NRW Flood Model Comments Response to NRW

PROJECT NUMBER	7005-3561
DATE	May 2021
PROJECT NAME	Leckwith Quays
CLIENT	Phil Worthing
DOCUMENT REFERENCE	70053561-C-Mem02-00

NRW have provided a set of comments (11/03/2021) on the hydraulic model submitted as part of the planning application. This memorandum sets out WSP's responses to each of these comments in turn.

Figure 7.1: Stage difference centred on Cardiff Bay in 2D Representation.

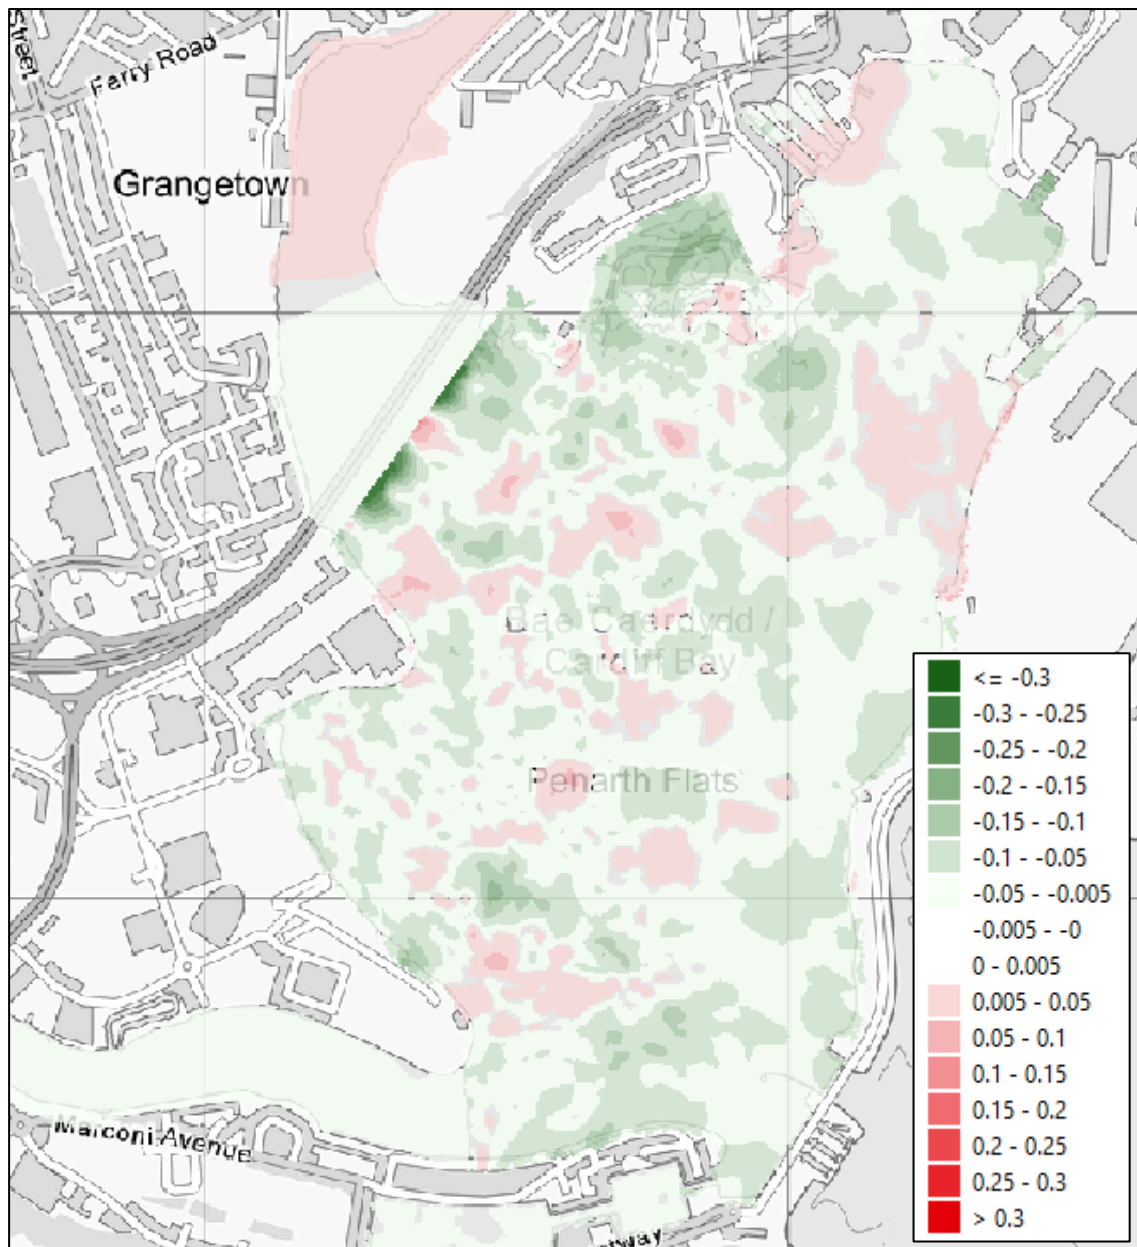
NRW require additional justification on the update of Cardiff Bay from 2D to 1D.

NRW will also note from the provided results files which represent the Bay as a 2D feature the striations and mottling across the bay in even low return period events when coloured against NRW's 5 mm difference criteria. Such mottling patterns are not typically indicative of a good performing model and introduce additional noise when trying to understand outcomes. Additionally, it is noted that large volumes of (static) water in the 2D domain can mask MB errors when considering model performance. Therefore, the representation of the bay in the 2D domain being an aspect which is not a focus for this project given its controlled nature and relation to the site it can be considered an unnecessary burden assuming that suitable 1D representation can be agreed.

As noted in the FCA as the conversion from the Baseline to the Refined Baseline resulted in a limited change in maximum stage levels through the site of interest as a result of the model refinements, with differences tending to a couple of centimetres if not a couple of millimetres. Therefore, this change is considered appropriate and a suitable representation of Cardiff Bay is not anticipated to significantly alter the conclusions of the modelling. Given the above explanation setting out why the 1D representation is preferable it is our consideration that this representation should be inherited into any future modelling for this project.

Figure 13.1: Sanitorium Park Overspill into Cardiff (SAN1) Hydrograph

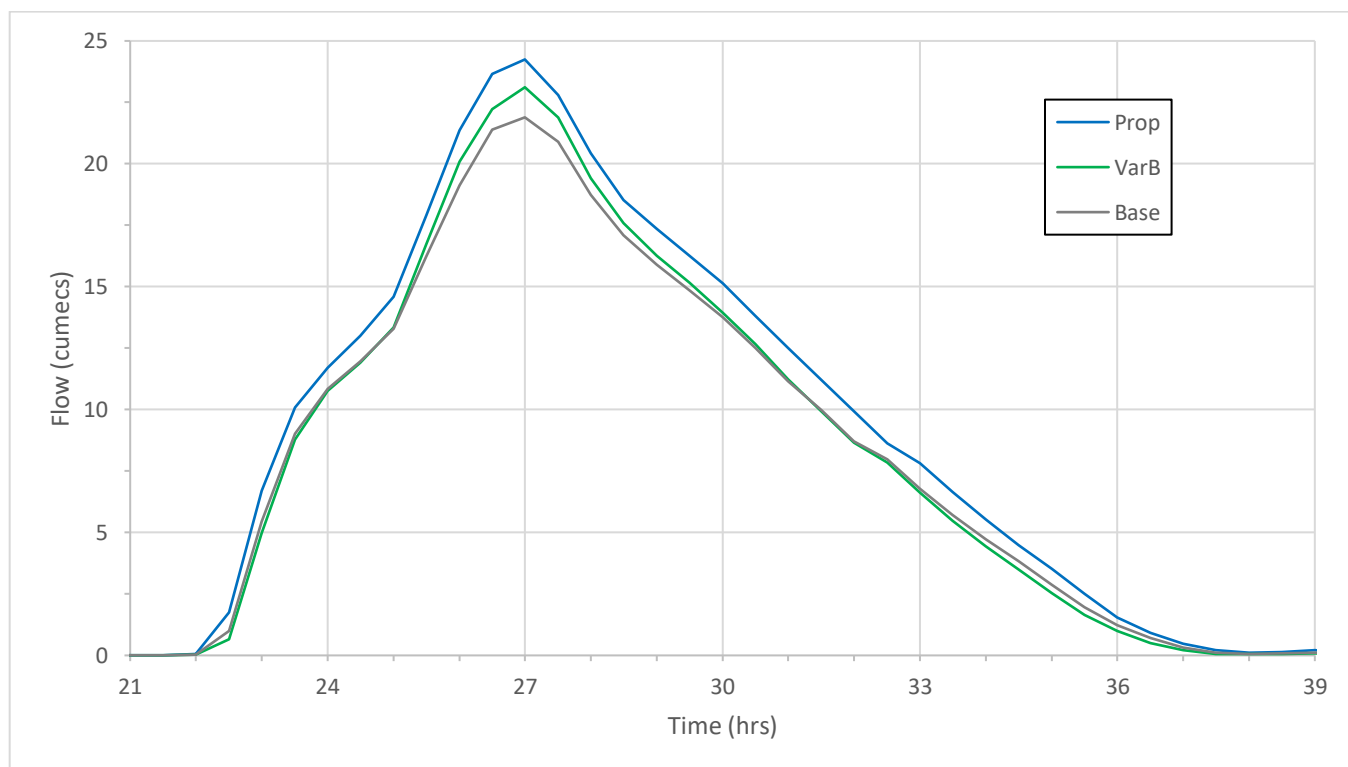
WSP must review and update the implementation of the proposed bridge and any associated culverts. In addition, detailed drawings of the proposed bridge must be supplied.

With regards to the observation that ‘they pass very little flow’. It is fully accepted that the total peak flow of 4.5 cumecs in the 1000yr event (254 Megalitres volume) may appear to be insignificant when compared to the flow passed through the Historic Bridge (175 cumecs) at only 2.5%. However, when considering the peak flow out of the upstream floodplain into Cardiff, which in the original proposal was some 55 cumecs occurring between 20 and 30 hours in the simulation; then the release of 254 Megalitres from the floodplain which also delays the driving flow spreading out over Cardiff, reduces the peak, the whole curve and brings forward the severance of the flowpath, then the resulting effect becomes significant. This can be seen in the figure below which shows one of the PO over spills (SAN1) into Cardiff.

The above figure more clearly shows the effect of the culverts on the floodplain, whilst the VarB peak flow remains higher than the baseline it is reduced from the initial proposal, additionally it can be seen that the

rising and falling limbs show less floodplain flow in VarB compared to the baseline with a later start and earlier termination. This is a logical consequence of the bypass culverts.
